Proposed Solar Development on Land Between Hawksworth and Thoroton

Grid Connection Structure Options Assessment

**Hawksworth and Thoroton Action Group (HTAG)
(Rule 6(6) Party)**

Planning Inspectorate Reference: APP/P3040/W/23/3330045

Extract from Figure 4 Infrastructure Layout (RES Drg No. 04668-RES-LAY-DR-PT-004 Rev 6).

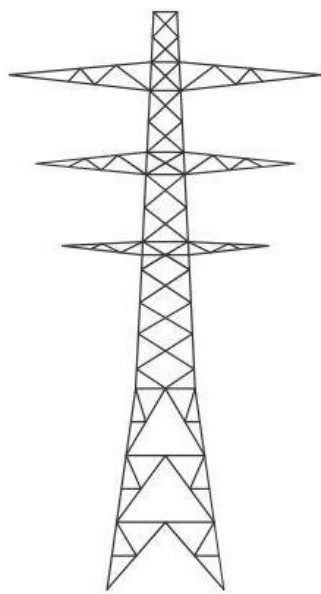
- 3.1 The Options Plans show that the proposed structure/s would be situated adjacent to the proposed DNO substation, which would be located in the centre of Field 8, in the south-eastern sector of the site.
- 3.2 Although not clear from the Options Plans, I assume that the structure/s would be located at the eastern end of the substation complex, as the existing pylon / cable line is east of the substation (c. 50m away at that point), and the Masterplan and Infrastructure Layout Plan show a small, square area extending from the substation complex at its eastern end, which corresponds to the area taken up by the connection structure shown on the Options plans – see below.

L4(m) DT STD

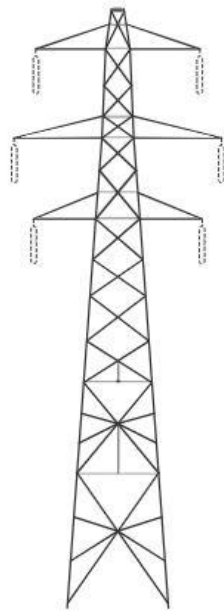
- 5.18 In addition, if the proposed pylon is the L4(m) DT STD type, then the difference in design between that and the existing pylon (probably L132 / equivalent L16 D2) would also be a noticeable visual anomaly (see comparison overleaf, but note not at / to scale).
